Report of the Committee on

CODE-MAKING PANEL NO. 1

National Electrical Code[®]

Articles 90, 100, 110, Annex A, Annex H

ILLUSTRATION
UTILITY ELECTRIC SUPPLY AND
PREMISES WIRING

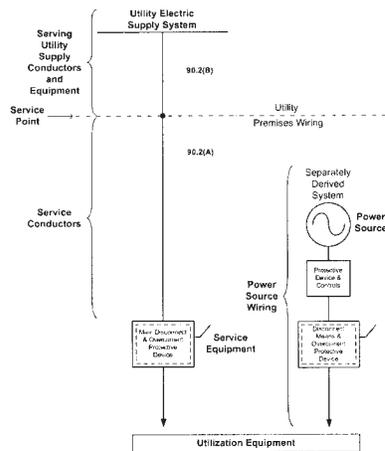
The proposed Figure is too general for practical application to all installations.

LABRAKE, JR., N.: This diagram and the associated definitions are proposed for an Annex where they would not be considered mandatory but could provide valuable information concerning the application of the NEC.

I disagree with the Panel statement that the diagram is “too general” for application in the NEC. Similar “general” diagrams exist in Section 210.52(C)(1), 410.2, and 514.3. This diagram (and the others) provides valuable guidance for the application of the NEC. Similarly, I disagree that the diagram does not provide additional clarity and usability to the NEC.

Substantiation: The drawing is a good representation of the Service Point definition and shows that this point is not defined by a specific piece of equipment like a disconnecting means, but will change depending on the utility/custom arrangements. The coverage of the Code and where it applies versus the NESC is a complex one. Even though this figure may not perfectly apply to all examples, it is better than what we have available today.

Informational Note Figure 694.1(A) Identification of Small Wind Electric System Components – Interactive System.

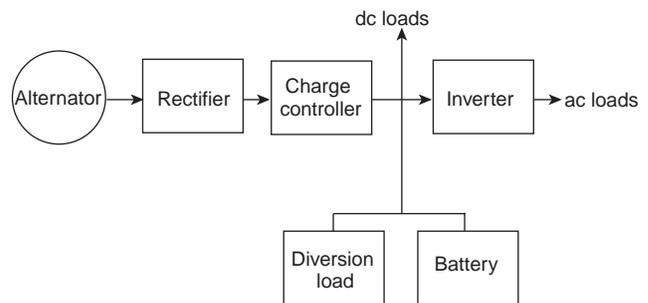
Informational Note: These Systems Small wind electric systems can be interactive with other electrical power production sources or might be stand-alone systems. These systems can have ac or dc output, with or without electrical energy storage, such as batteries. See Informational Note Figures 694.1 and 694.2.
